ENGINEERING MEMORANDUM

REPAIR SCHEME
RUDDER & BRAKE PEDALS

E.M. NO. 17088 "C"

TYPE AIRCRAFT **EXPEDITOR 3**

SECTION AT A

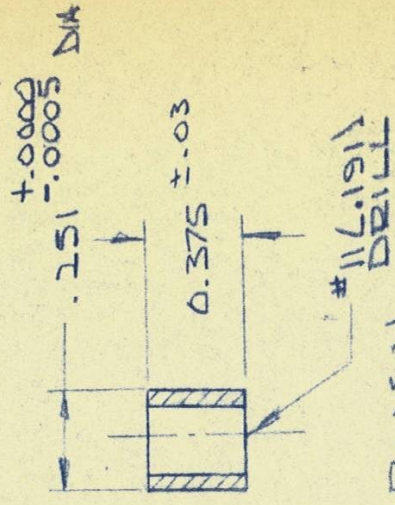
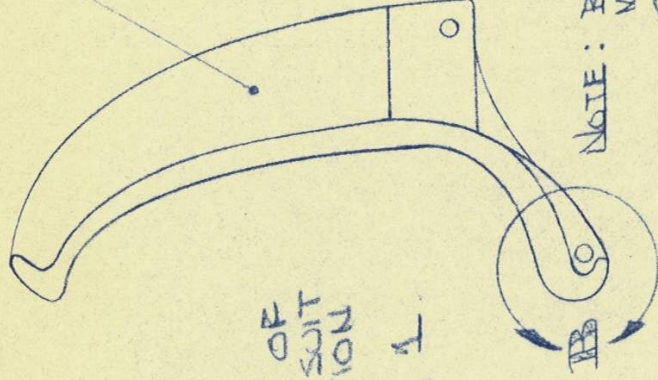
BUSH
1 REQ'D

NOTE: TRIM ENDS OF BUSH TO SUIT UPON INSTALLATION.

SECTION AT B

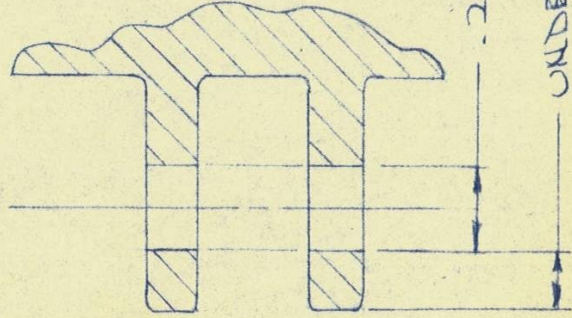
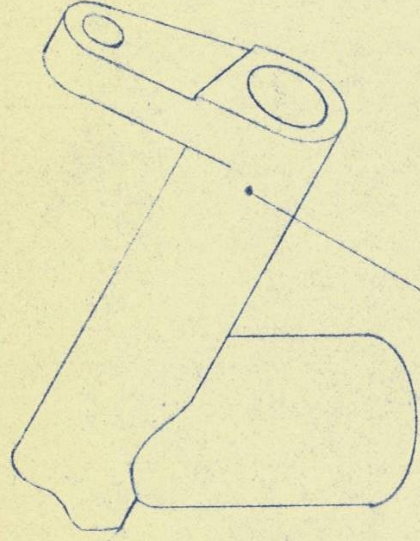
NOTE: TRIM END OF
BUSH TO SUIT
UPON INSTALLATION

SEE NOTE SHT. 1

NOTE: BOTH LUGS ON A SIDE
MUST BE REPAIRED IF
ONE LUG REQUIRES
REPAIR.

UNDER NO CIRCUMSTANCES
MAY THIS DIMENSION BE
LESS THAN .125" AFTER
REPAIR.

RE: REPAIR SCHEME SHT 3.
NORMALLY- IF "B" WORN BEYOND LIMITS (SEE E.M. 12087) THE PEDAL MUST BE REPLACED. THE REPAIR SCHEME AS SHOWN WILL APPLY ONLY IF PEDAL SUPPLY IS SHORT AND CONSEQUENTLY AN A/C WILL BE DELAYED.

404 - 187929

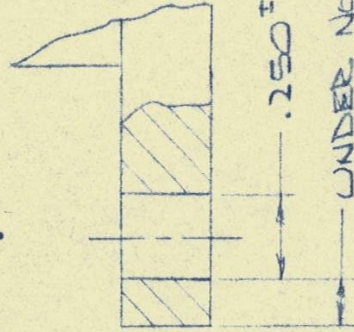
UNDER NO CIRCUMSTANCES
MAY THIS DIMENSION BE
LESS THAN .125" AFTER
REPAIR

NOTE: TRIM ENDS OF BUSH TO SUIT
UPON INSTALLATION
